HORIZONTAL DIRECTIONAL DRILL ANALYSIS
ROUTE 897, WETLAND B72PEM, & STREAM S-B82 CROSSINGS
PADEP SECTION 105 PERMIT NO.S:
PA-LA-0024.000-RD & PA-LA-0024.000-RD-16
(SPLP HDD# S3-0170)

HORIZONTAL DIRECTIONAL DRILL DESIGN SUMMARY: 20-INCH & 16-INCH

RE: Sunoco Pipeline, L.P. Pipeline Project - Mariner East II

Hydrogeological Re-Evaluation Report

ATTACHMENT 2 ORIGINAL AND REVISED CONSTRUCTION PLANS

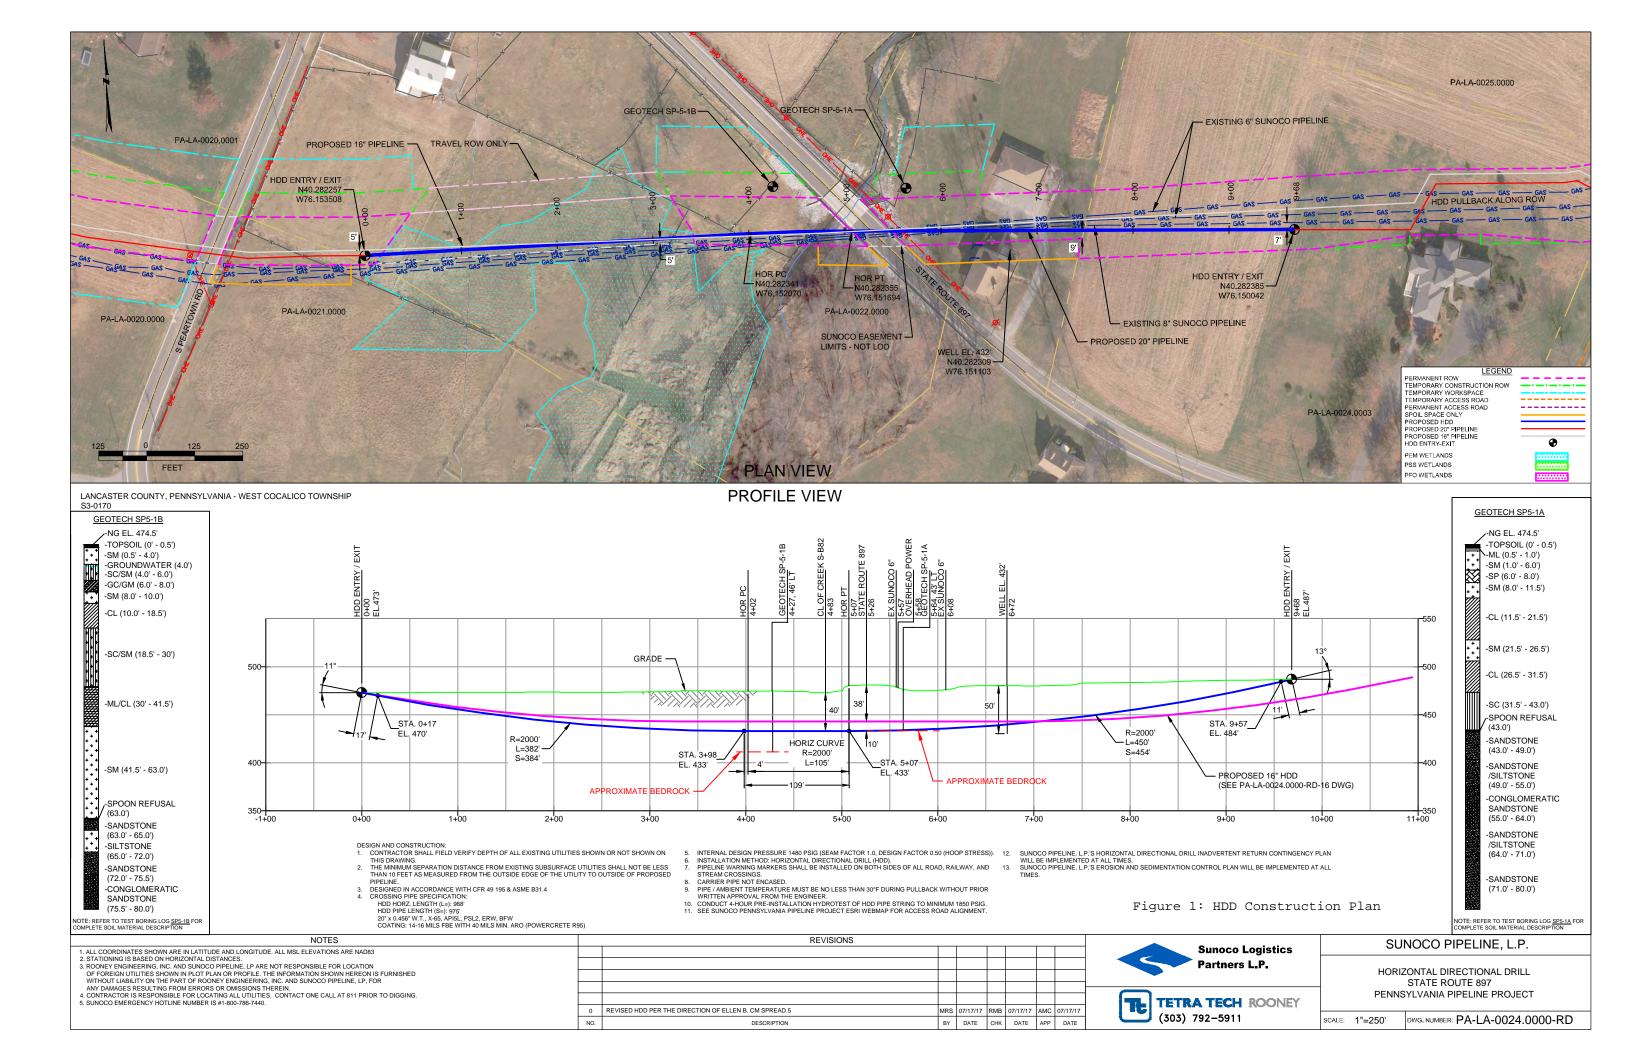
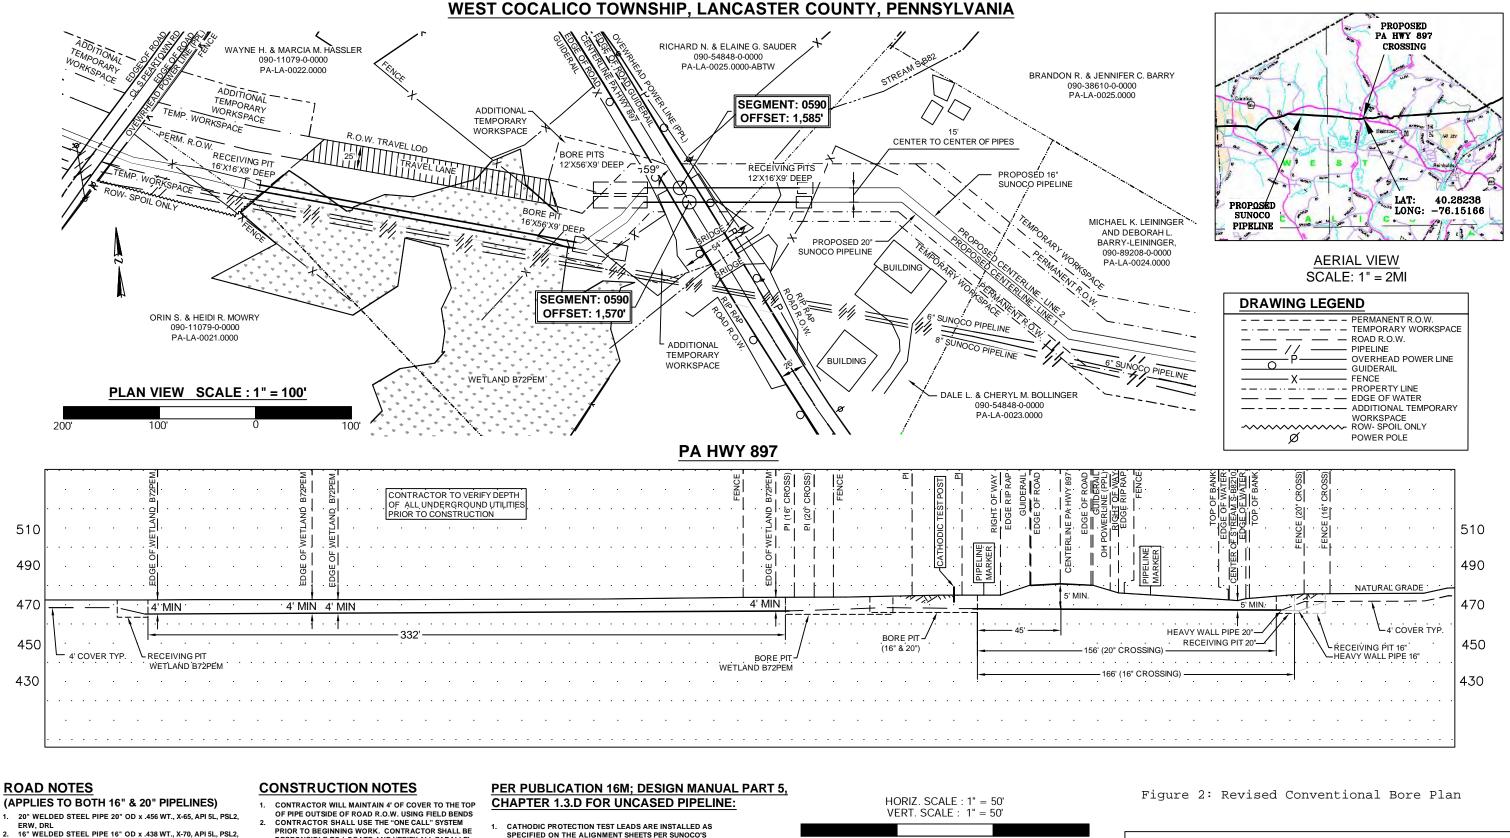
The HDD was the first alternative plan of installation to avoid impacts to the stream, wetland, and residence area as illustrated on Figure 1 in Attachment 2.

The third and final plan of installation is illustrated on Figure 2 in Attachment 2. This alternative route and construction plan creates a new permanent utility easement outside and separate from the existing utility easement, creating an additional encumbrance to the property of the affected private landowner; however by use of conventional bores, avoids direct impacts to the roadway, stream and wetland.

As illustrated on Figure 2 in Attachment 2, the revised plan of construction is to install the 16-inch and 20-inch pipelines by a combination of two (2) conventional horizontal bores (not HDD) and open cut (trench) construction.

The existing limits of disturbance (LOD) are sufficient to accommodate this revised plan of construction and does not require a modification of any state or federal permits.
